TOWN OF WILTON
ADDENDUM NO. 2

RFP #2022-09

**Request for Proposal to Replace Lovers
Lane Bridge - Bridge #04975**

ADDENDUM NO. 2

ABUTMENT 1 (SOUTH) PLAN

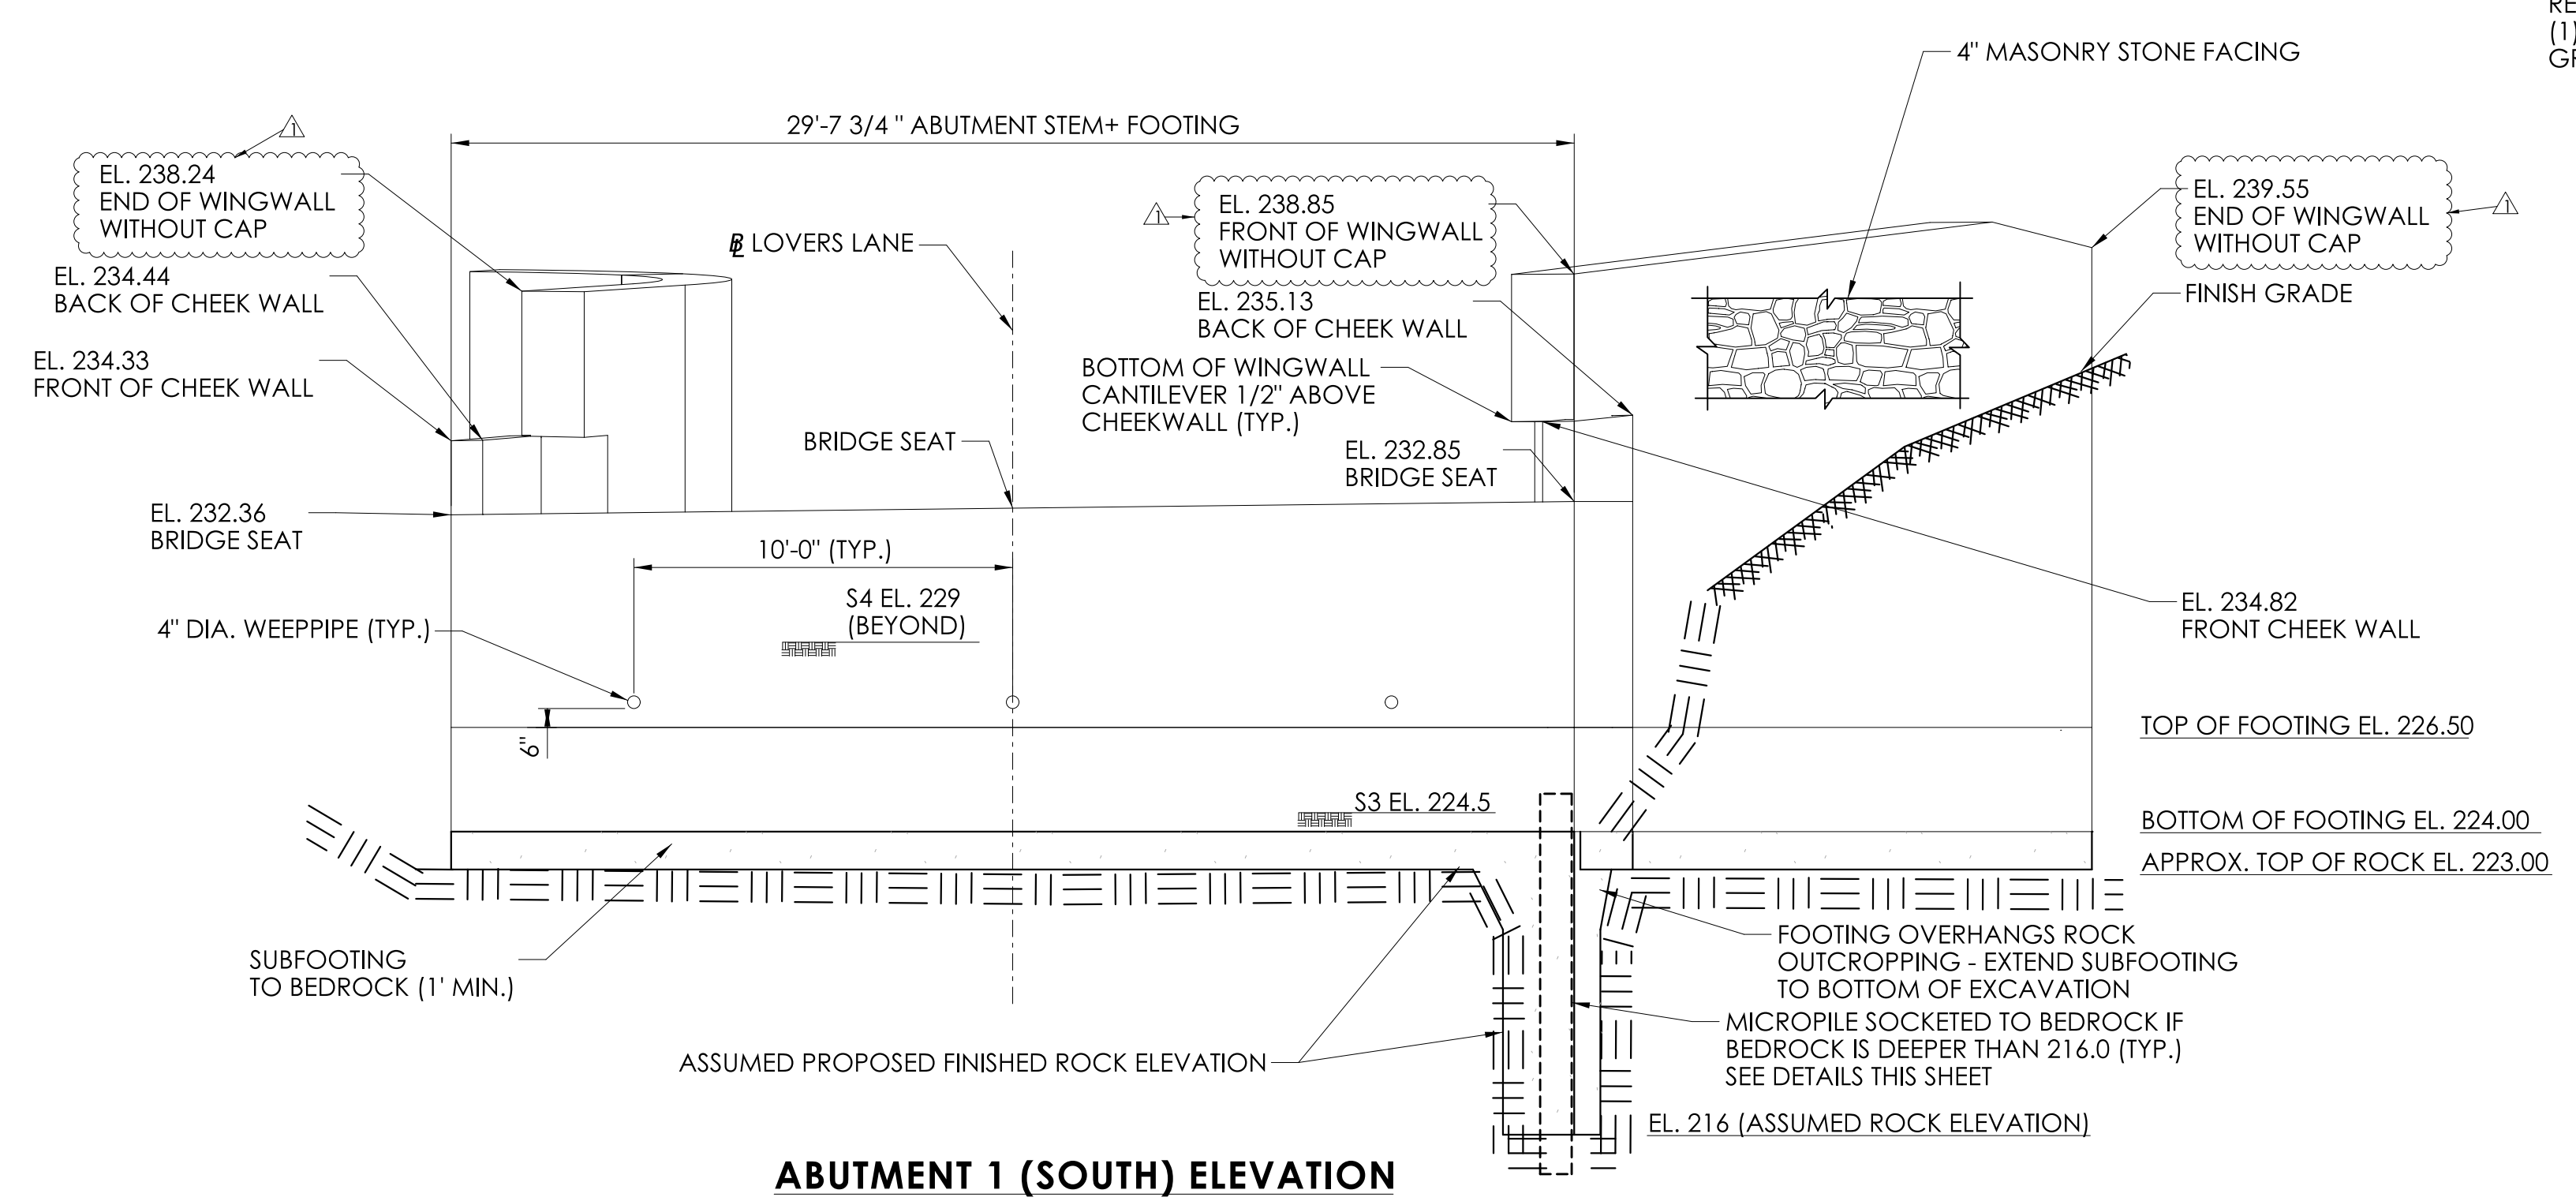
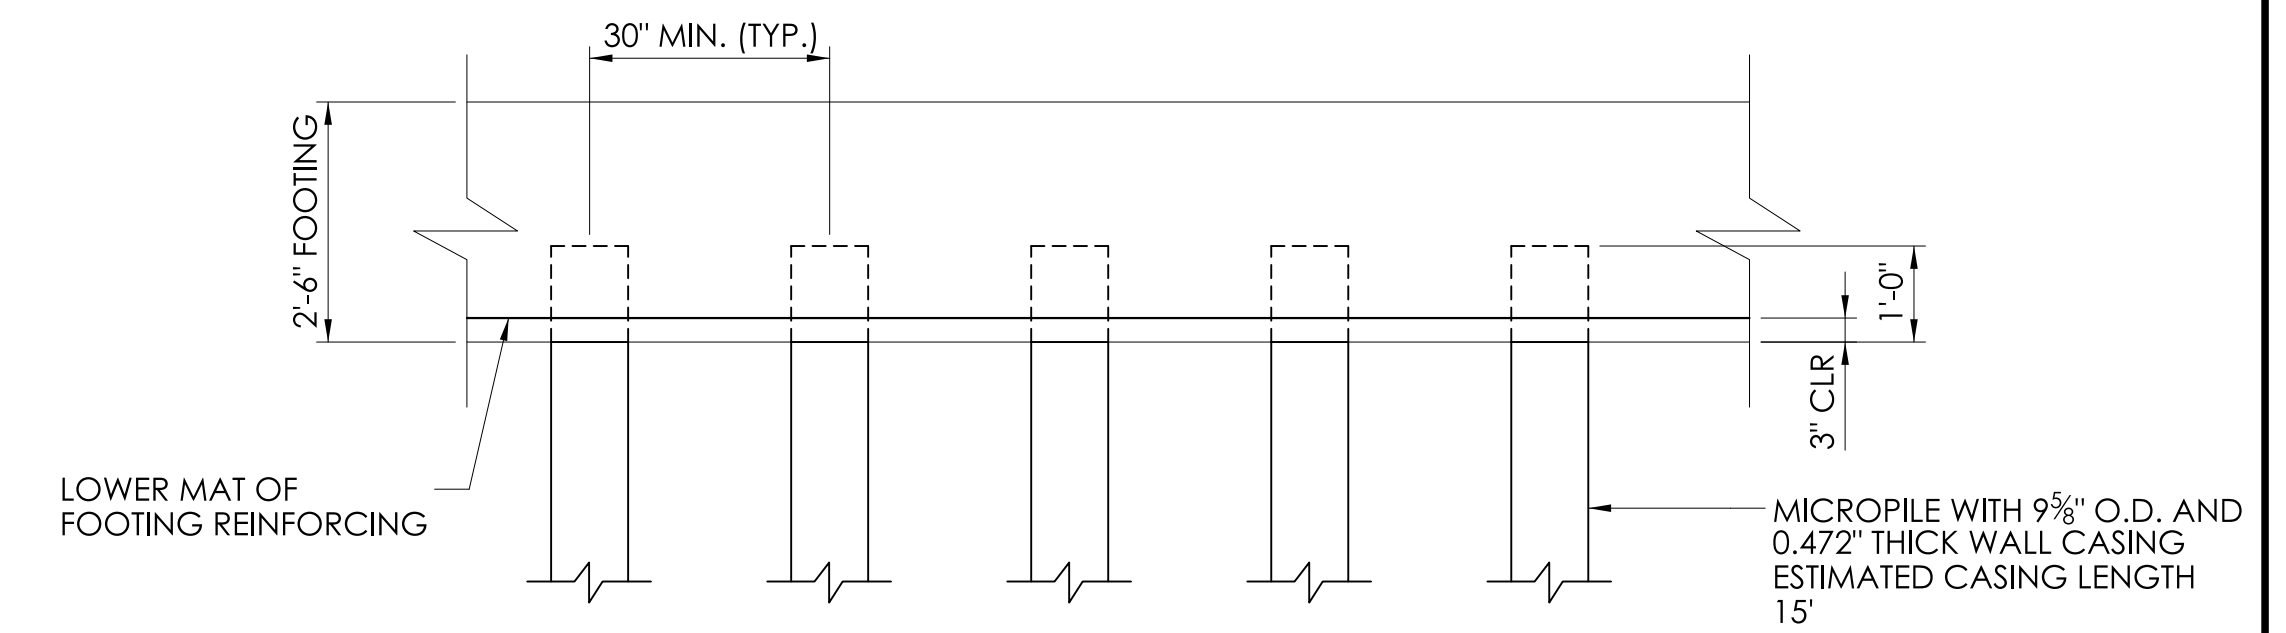
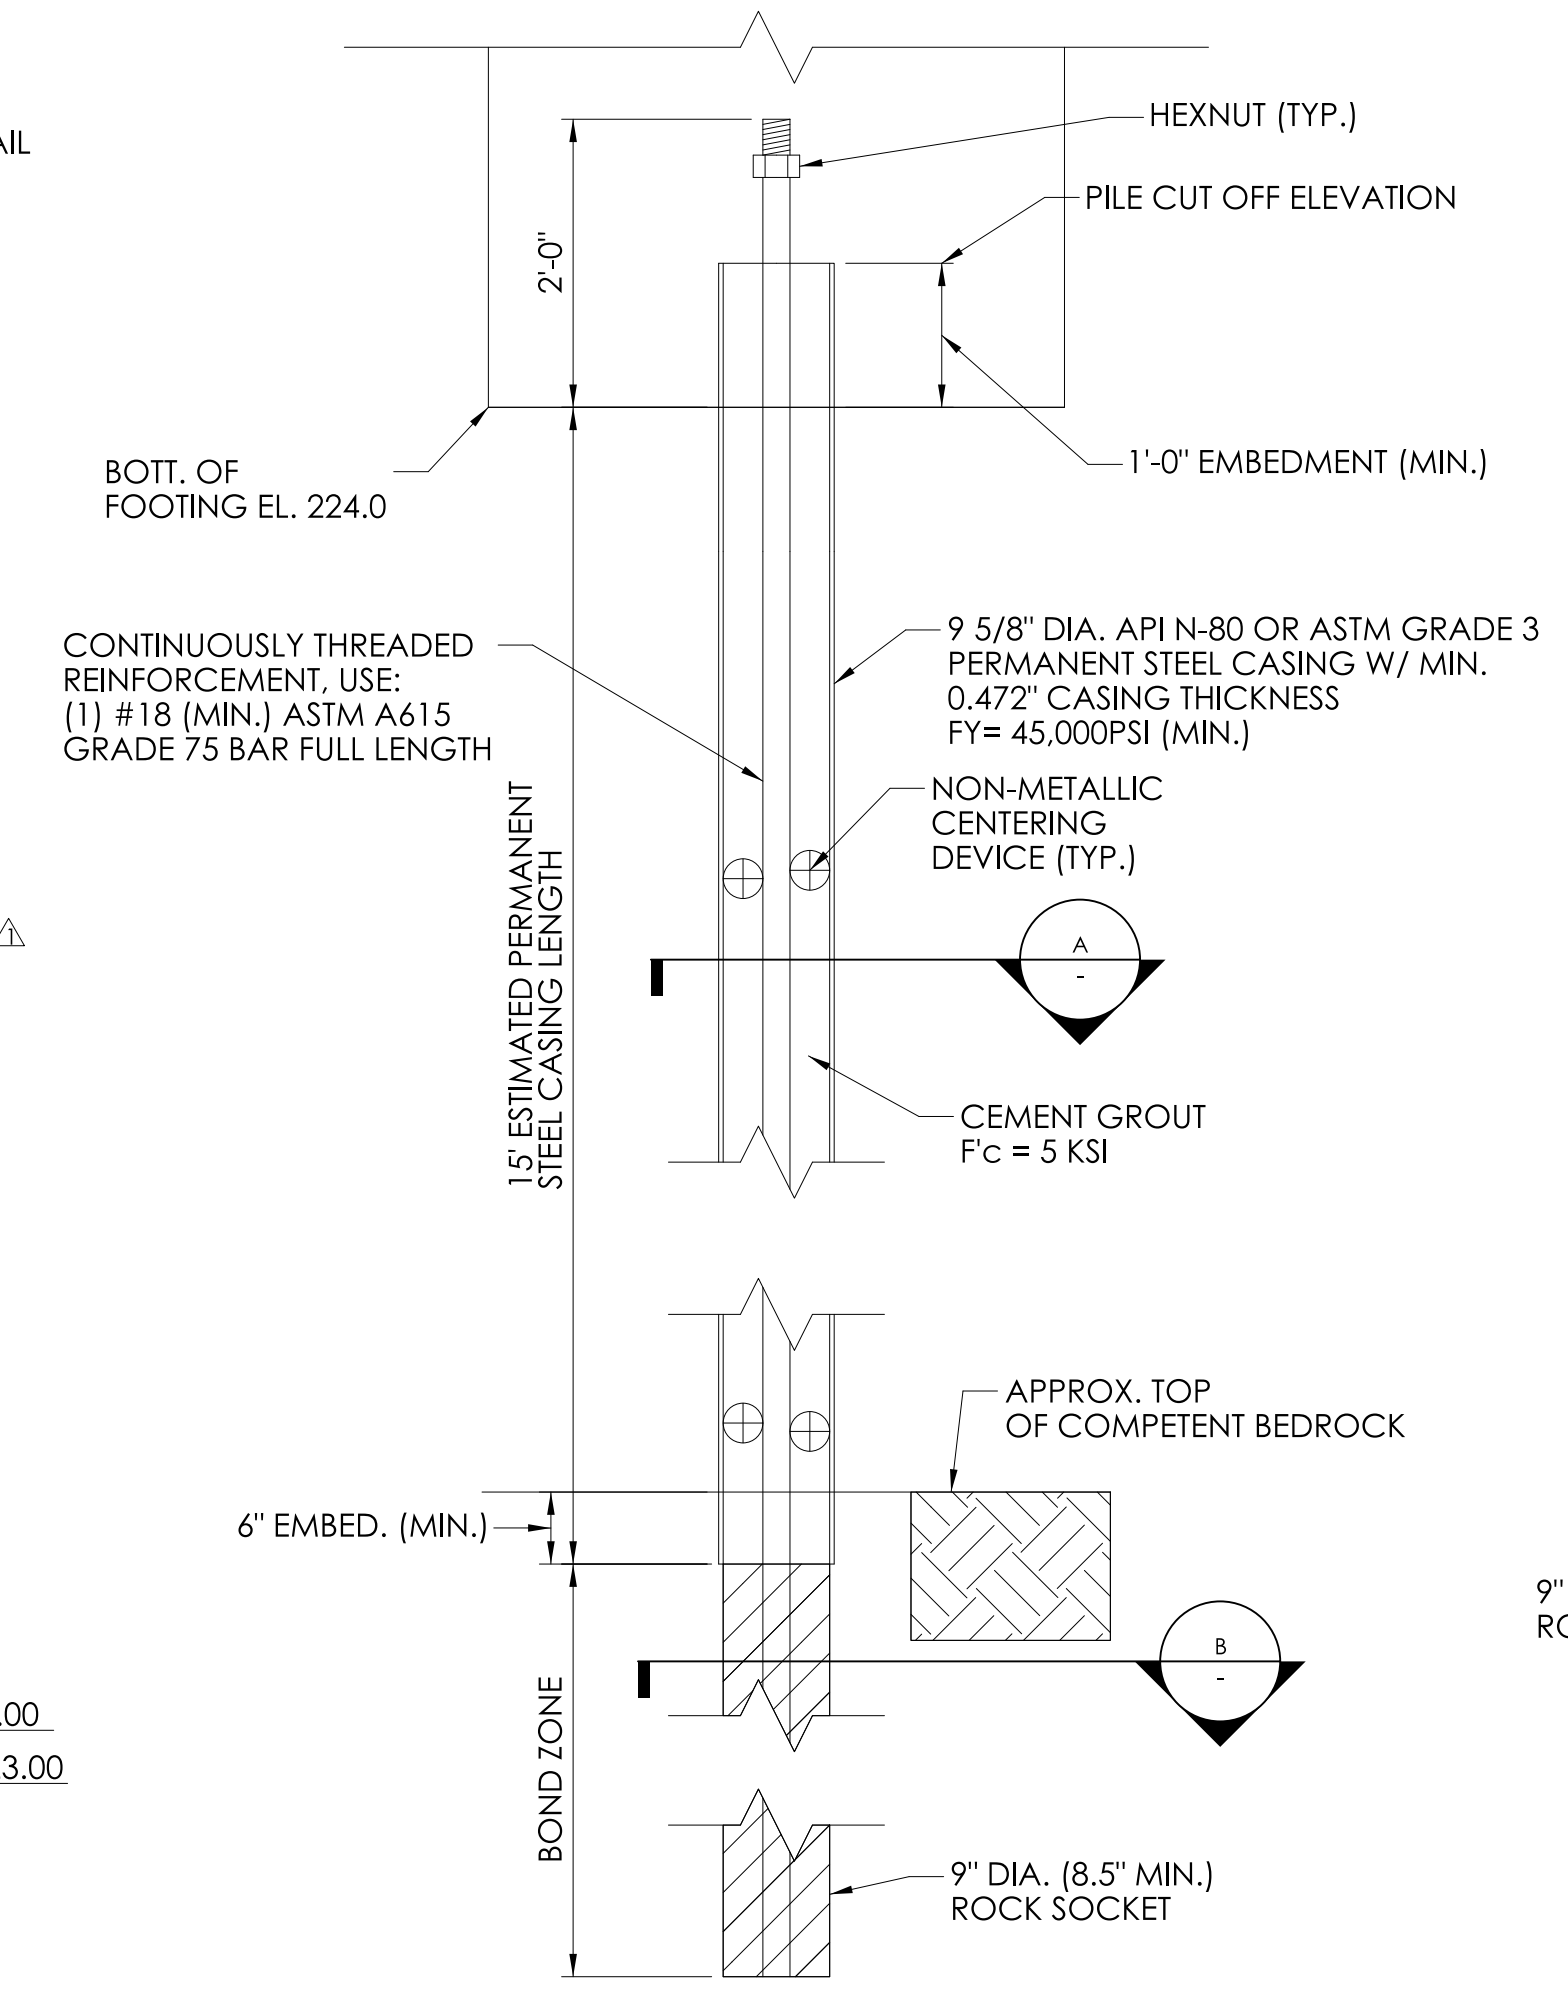
REV.	DATE	DESCRIPTION
1	12/15/22	ABUTMENT REVISIONS

PROJECT NUMBER: 0161-0142
 PROJECT DESCRIPTION: REPLACEMENT OF BRIDGE NO. 04975 LOVERS LANE OVER COMSTOCK BROOK
 TOWN(S): WILTON
 DRAWING TITLE: NORTH ABUTMENT 2

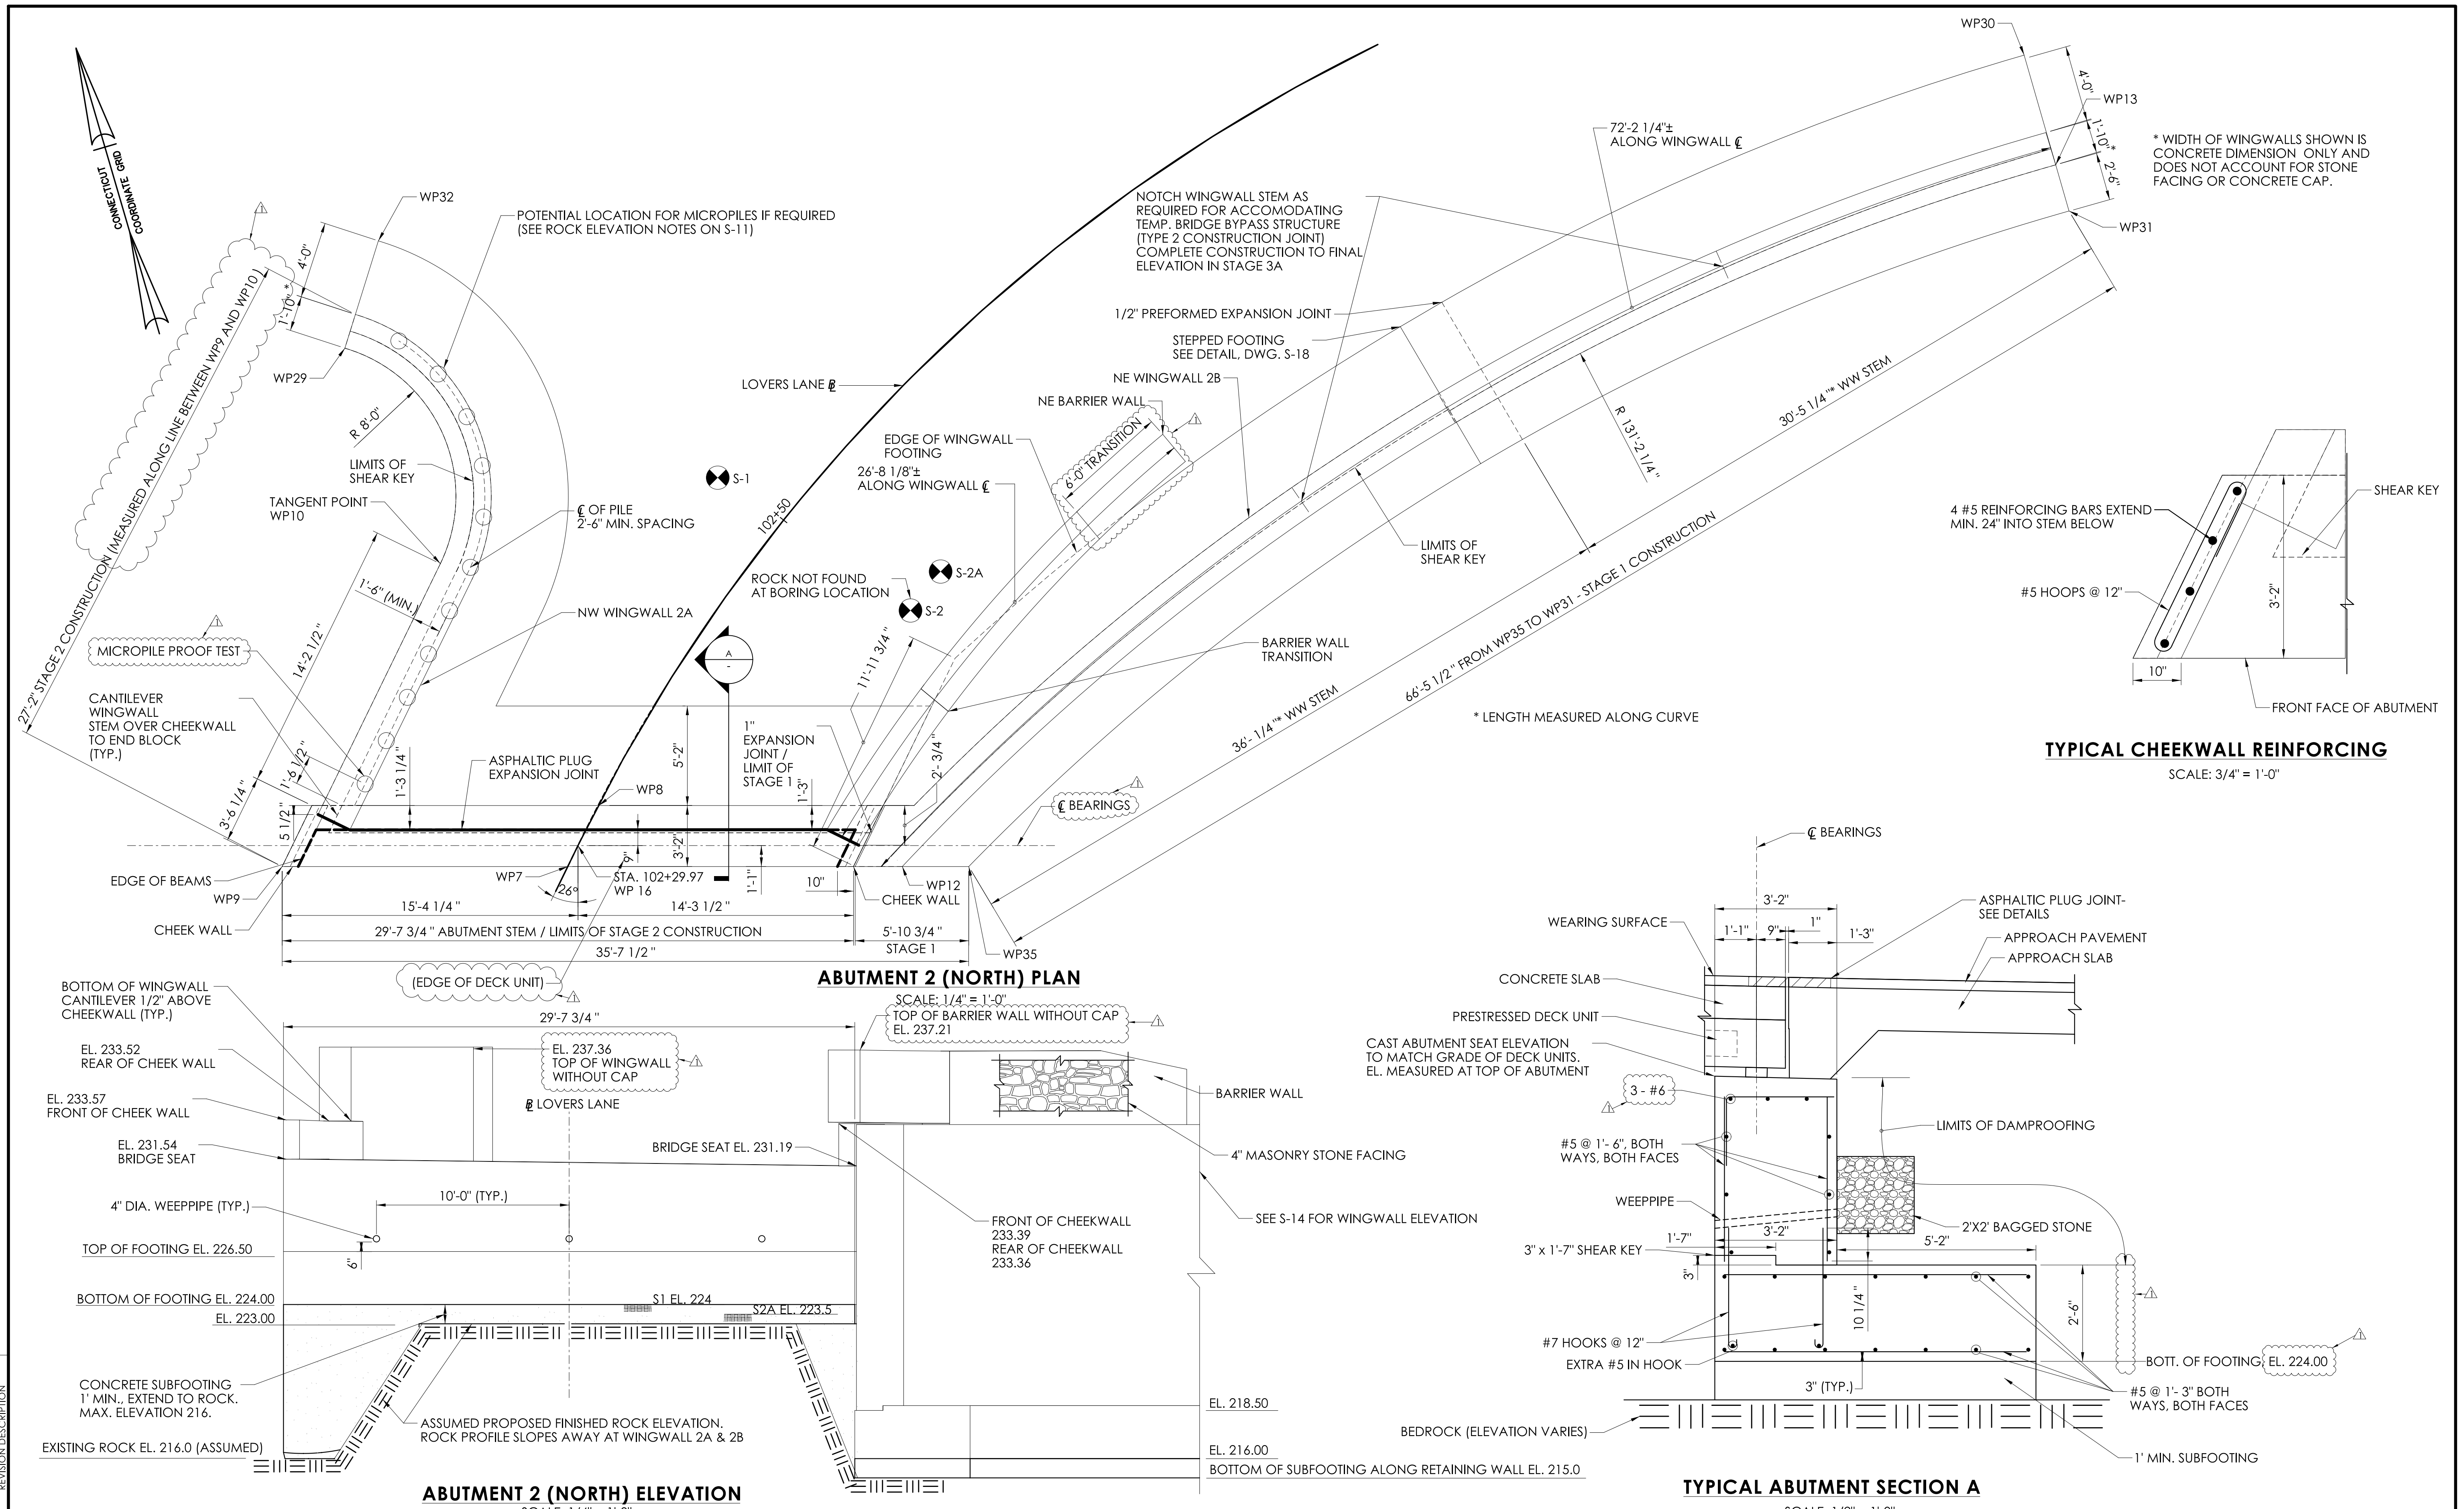
REV.	DATE	REVISION DESCRIPTION
1	12/15/22	REVISE ABUTMENT
